TAL-CO SUPPLEMENTAL INSTRUCTION #36 R-2			
Project Name:	RW TOMLINSON - NEW HEAD OFFICE		
Project Location:	100 CitiGate Drive, Ottawa, Ontario		
ARCH. SI #:	N/A	Issued By:	Chris Simpson
STRUC. SI #:	N/A	Date Issued:	March 15, 2017
MECH. SI #:	SKM-42-R1, 43-R1, 44-R1,	Revision #:	2
ELEC. SI #:	45-R1	Revision Date:	May 9, 2017
	N/A

Title: Floors 2, 3 & 4 Typical Electrical/Mechanical/Sprinkler Elevation Drawings for Coordination

Sketches show elevations as agreed to during the 28-Feb-17 meeting with CPE, Vipond & Optimum Mechanical & Tal-co. See SKM - 42-R1, 43-R1, 44-R1, and 45-R1 for revised dimensions.

2
TYPICAL SECTION - 2nd & 3rd FLOORS
M123
1:50

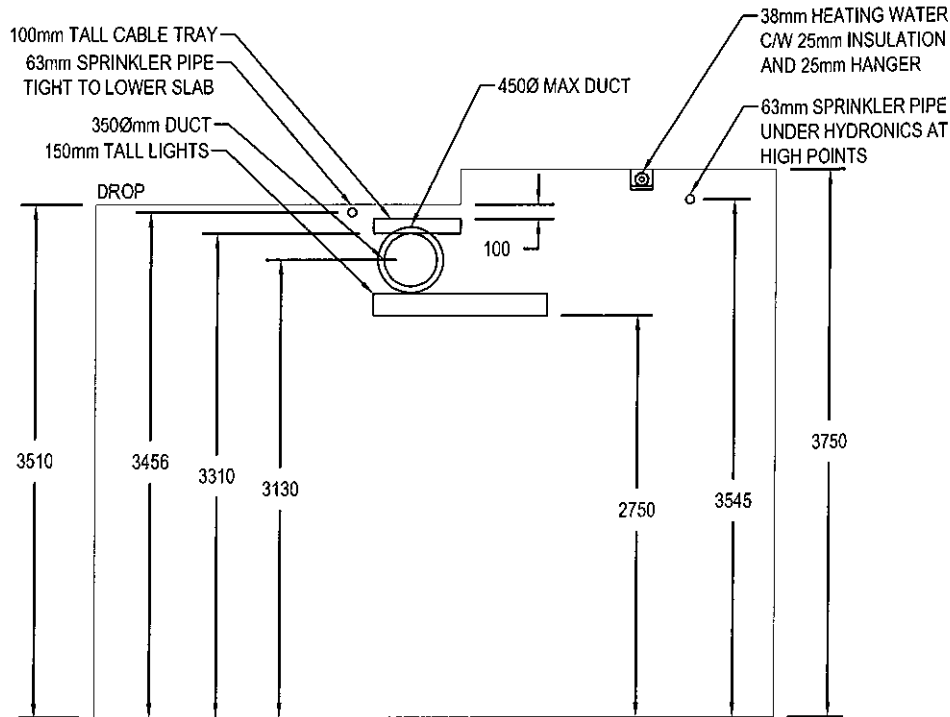
1. ALL SPRINKLER PIPING TO BE RUN TIGHT TO THE DROP (LOWER CEILING SLAB).
ACCOUNT FOR 75mm.
2. ALL PLUMBING & HYDRONICS TO BE RUN BELOW SPRINKLER PIPING AT LOWER CEILING SLAB.
ACCOUNT FOR 140mm.
3. ALL PLUMBING & HYDRONICS TO BE RUN TIGHT TO CEILING SLAB AT THE HIGH POINTS.
ACCOUNT FOR 140mm.
4. ALL SPRINKLER PIPING TO BE RUN BELOW PLUMBING AND HYDRONIC PIPING AT THE CEILING SLAB
HIGH POINTS.
ACCOUNT FOR 75mm.
5. LARGEST DUCT SIZE CROSSING CABLE TRAY IS 350Ø.

3
M124
TYPICAL SECTION - 4th FLOOR
1:50

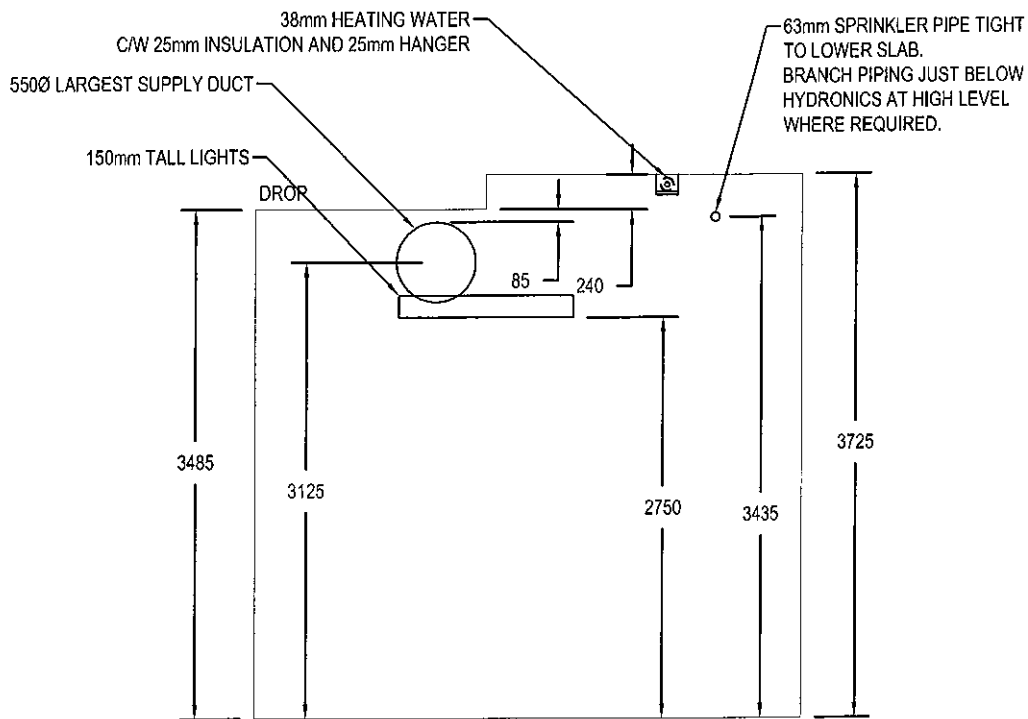
1. ALL SPRINKLER PIPING TO BE RUN TIGHT TO THE DROP (LOWER CEILING SLAB).
ACCOUNT FOR 75mm.
2. ALL PLUMBING & HYDRONICS TO BE RUN BELOW SPRINKLER PIPING AT LOWER CEILING SLAB.
ACCOUNT FOR 140mm.
3. ALL PLUMBING & HYDRONICS TO BE RUN TIGHT TO CEILING SLAB AT THE HIGH POINTS.
ACCOUNT FOR 140mm.
4. ALL SPRINKLER PIPING TO BE RUN BELOW PLUMBING AND HYDRONIC PIPING AT THE CEILING SLAB
HIGH POINTS.
ACCOUNT FOR 75mm.

To coordinate Electrical, Mechanical & Fire Sprinkler installation in ceilings.
 Note that these are typical elevations and may need to be adjusted as required to suit more congested locations.
 Elevations for 4th floor typical section have been revised, minor revisions to other areas.
